Date: August 10, 2007

**Subject: Dexter DX Series Electro/Hydraulic Actuators**

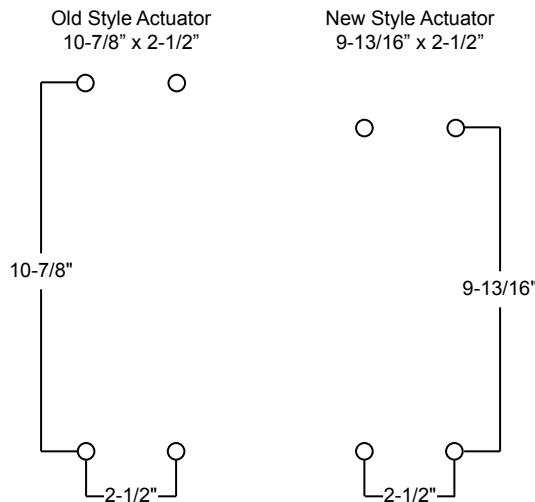
- Additional wiring protection to prevent damage to the actuator if wired improperly
- Larger brake fluid reservoir size — increased from 40 to 50 cubic inches
- All stainless steel fasteners for improved corrosion resistance
- New, more compact, housing design
- Still includes Dexter's two year limited product warranty

The new actuator design has a different mounting pattern as shown below.
